Clonburris SDZ,
Dublin 22

Ronan Mac Diarmada & Associates

ADDITIONAL INFORMATION RESPONSE

November 2022

Street Tree Location Plan

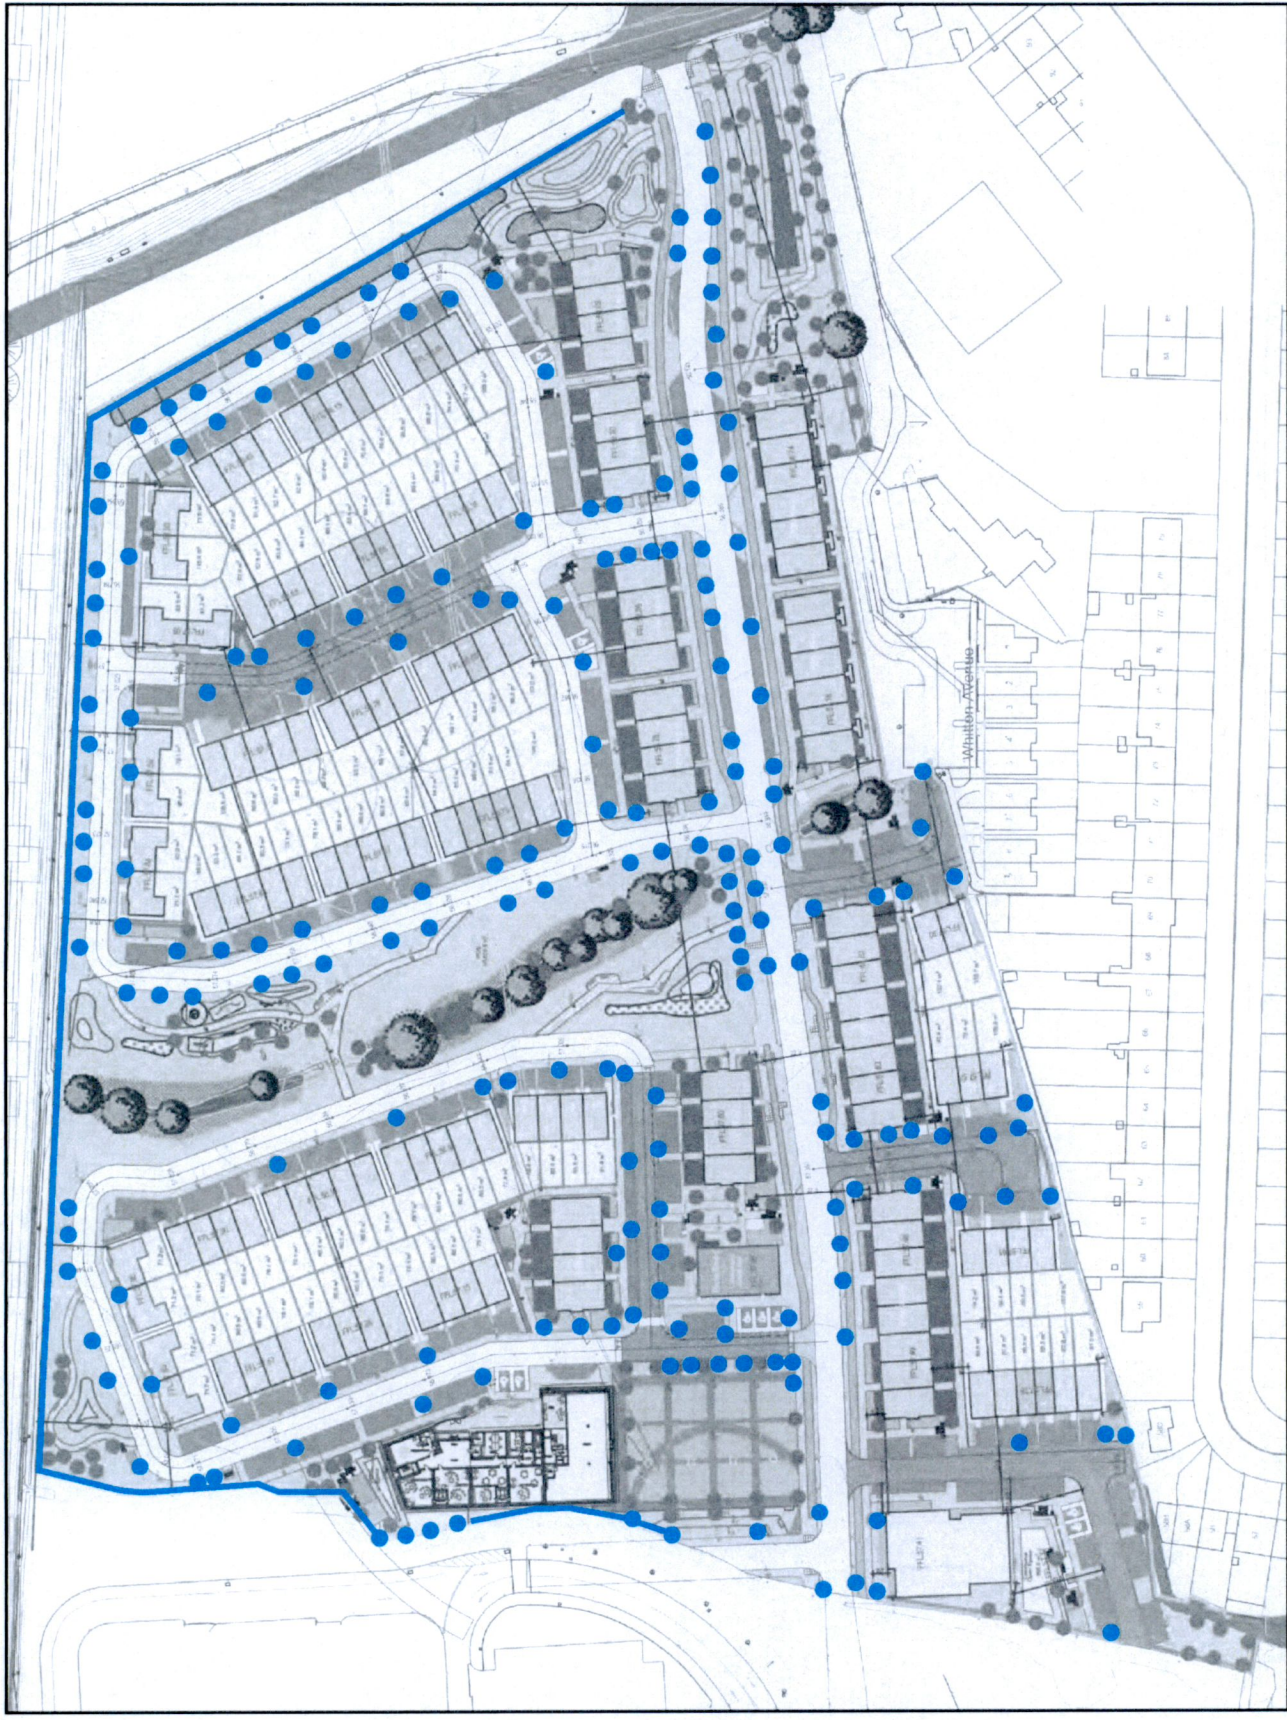
Street trees size at planting a minimum of 18 to 20-centimetre girth (cmg) within local streets and a minimum of 16 -18 cmg on intimate local streets (homezones) as per the requirements of the Clonburris SDZ Parks and Landscape Strategy.

(We feel the maximum size for the trees should be 16-20cm) Street sizes shall be at planting a minimum of 18-2cm girth and shall follow the requirements as per the Clonburris SDZ Parks and Landscape Strategy.

Retained Trees, New trees & Removed Trees Plan

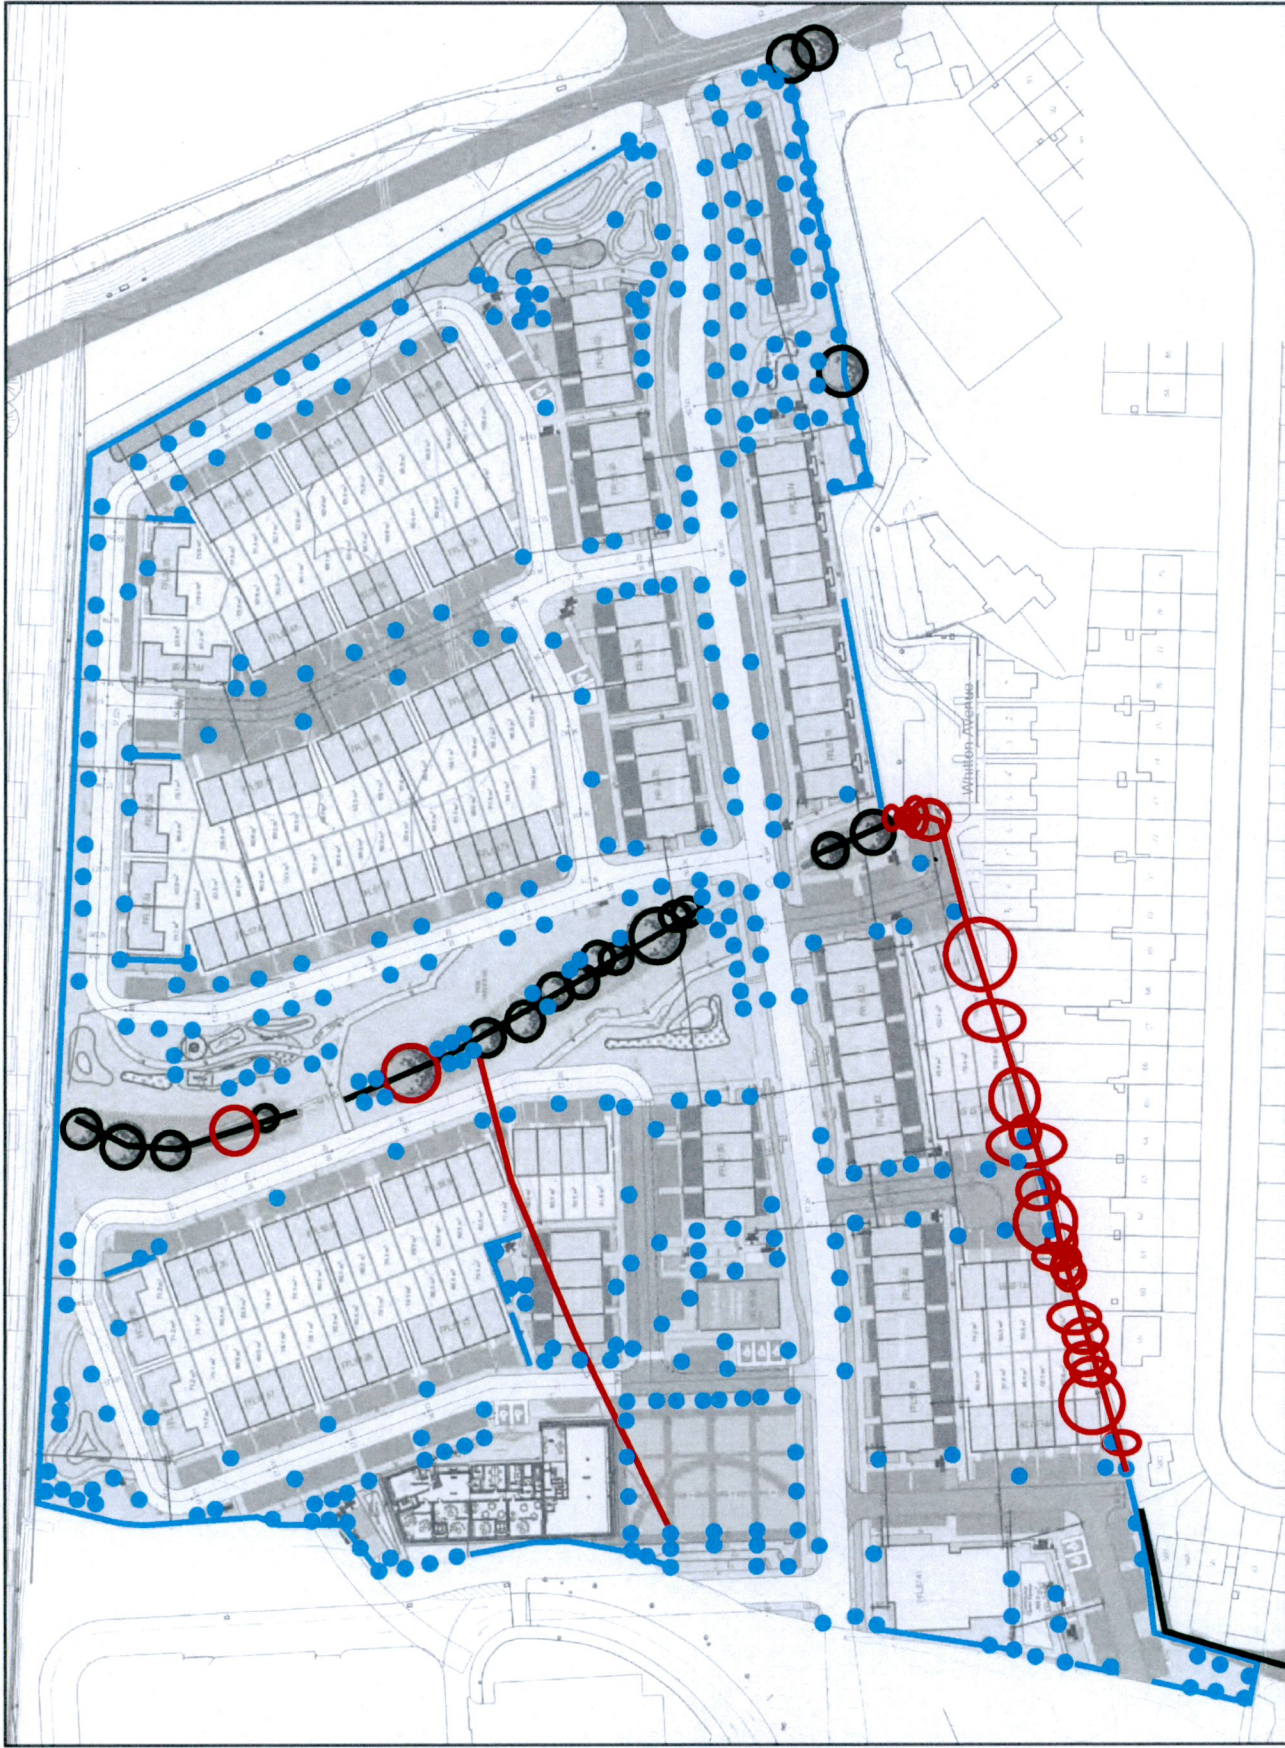
Retained, removed and compensatory hedgerow and trees to be clearly identified on Landscape Plans.

Trees and hedgerows are to be retained where possible. Any removed vegetation will be replanted with Native species. Please see hedge and tree planting identified as on Dwg.01 Landscape plan.

Parkland/ Open Space Tree Plan

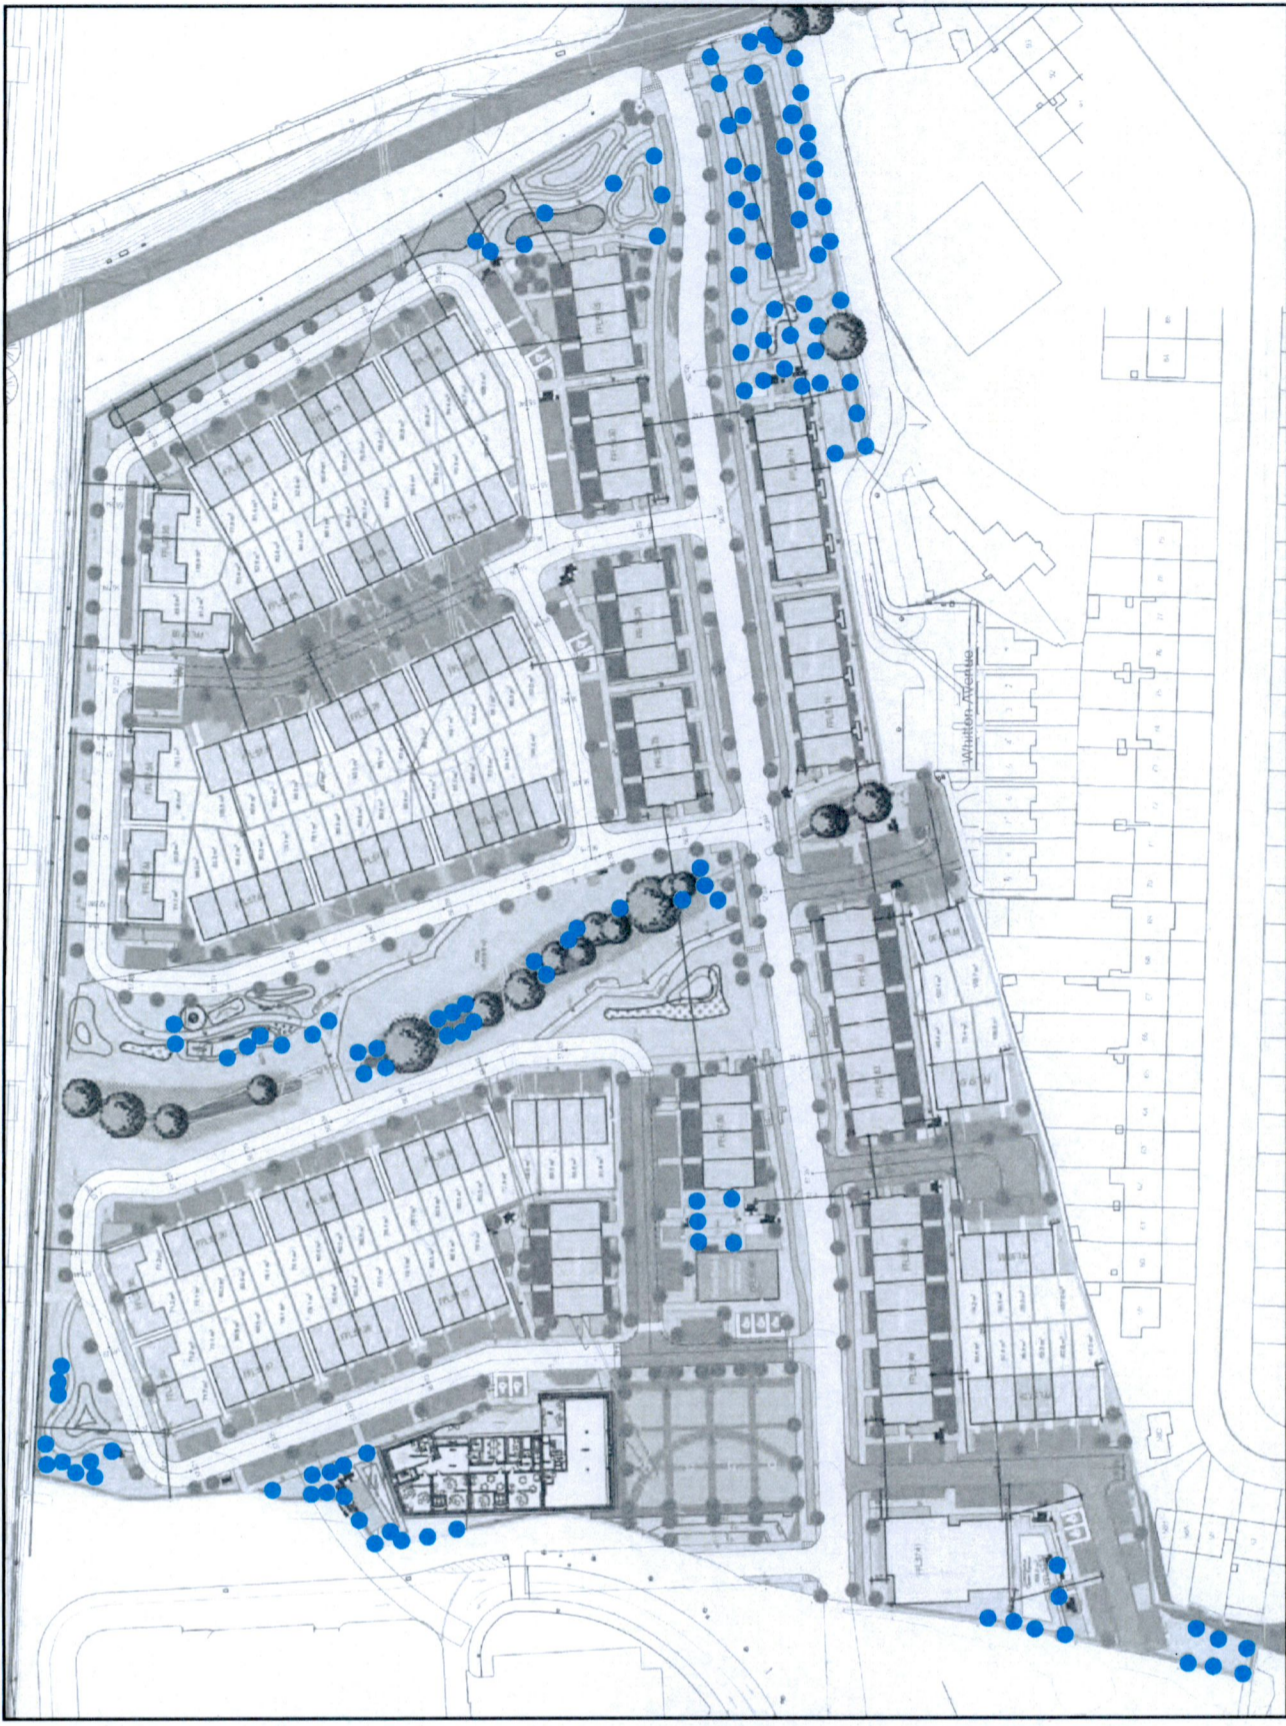
Parkland/Open Space tree planting to include a range of semi-mature specimens that are a minimum of 20-25cmg and specimen ornamental trees to include trees that are 30-35 cmg.

Parkland/Open Space tree planting to include a range of semi mature specimens at 20-25cmg and ornamental specimen trees at 30-35cmg.

We feel the maximum size of the trees should be 16-18cm as the larger sizes tend to fail when planted due to size.

Green Roof Location Plan

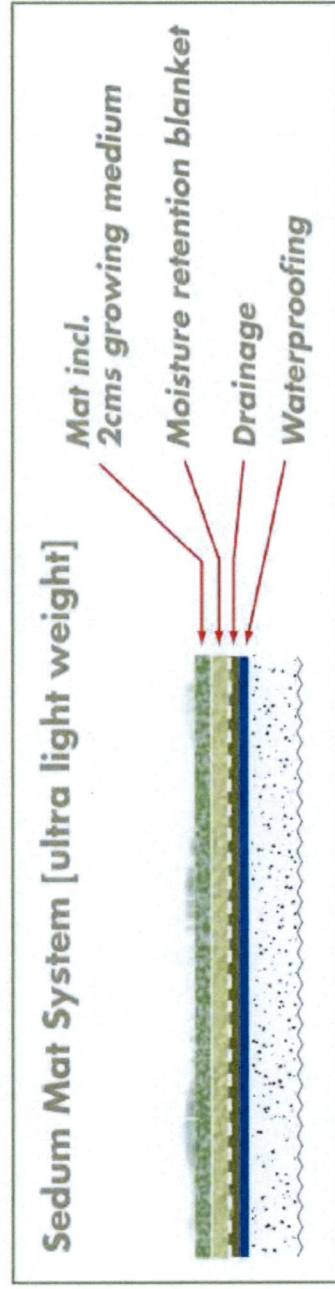
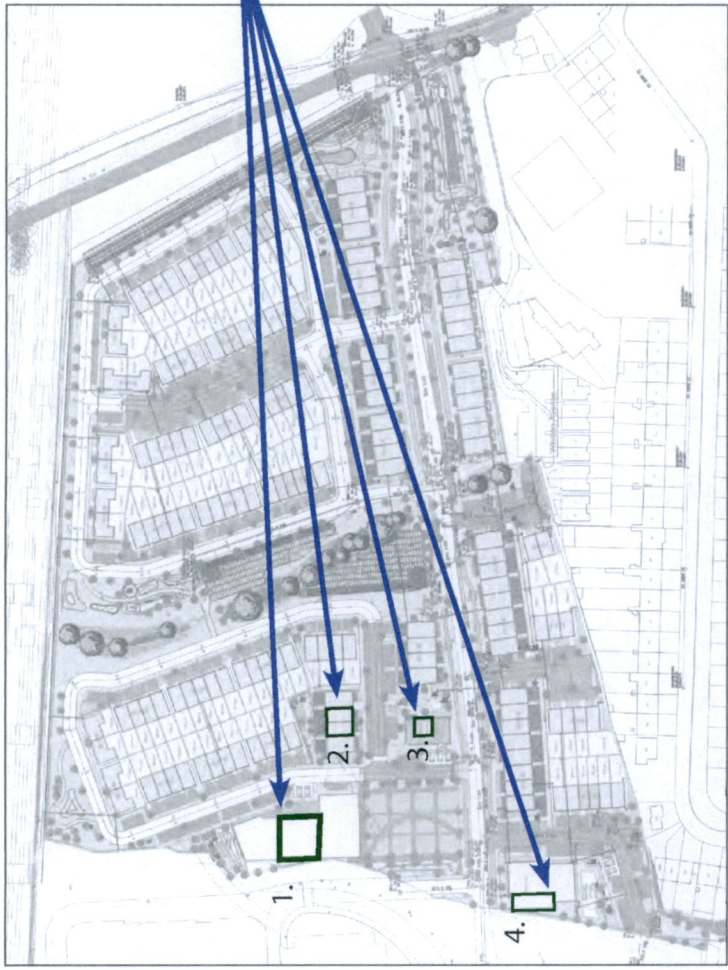
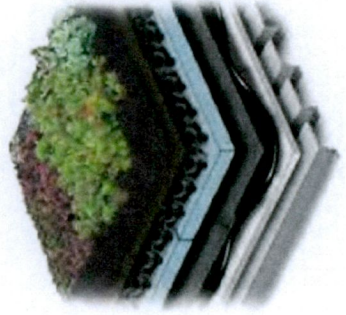
Details of all natural SuDS features including swales, rain gardens, bioretention tree pits, channel rills, filter strips, ponds, detention basins with lower areas allowed to fill first (low flow channels), wetlands etc.

Please see green roof detail.

Proposed Lighting Plan

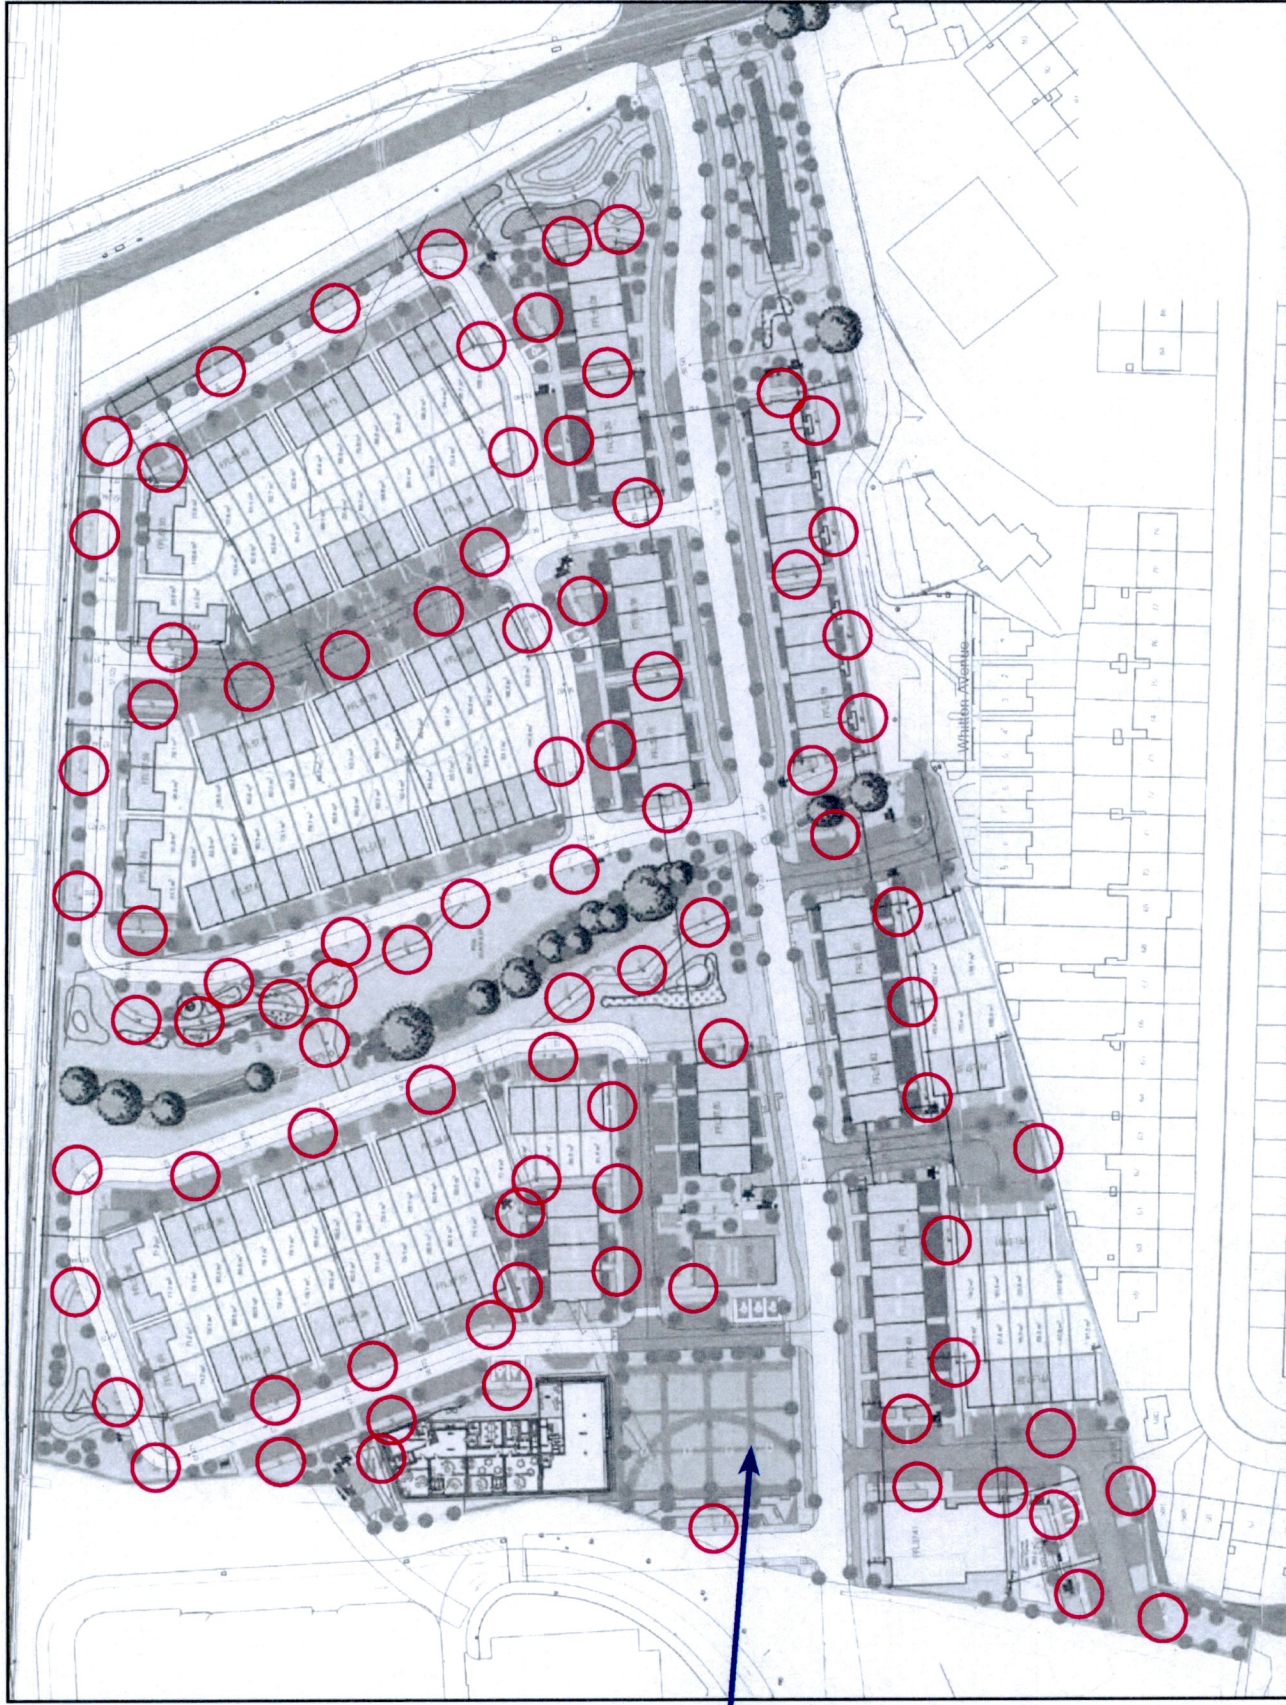
Landscape masterplan/planting plan to clearly delineate street lighting to ensure street tree proposals are realistic. If this is not currently the case, proposals to be revised to ensure street tree delivery

Please see Dwg 01 Landscape plan clearly delineating street lighting to ensure tree proposals are realistic. Trees have been placed at a minimum of 5m away from light standards to avoid any potential clashes.

Tree & Hedgerow Protection Plan

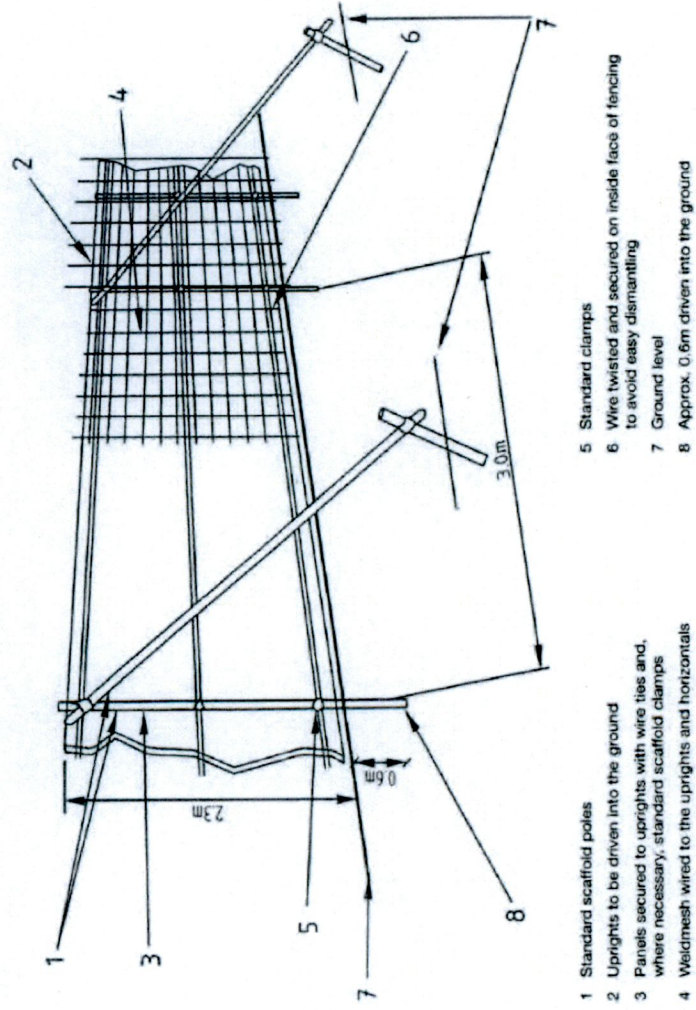
Tree and hedgerow protection measures: show extent and position of tree and hedgerow protection fences

Please see tree & hedgerow protection measures showing extent of position of tree & hedgerow protection fence, located in arborist report.
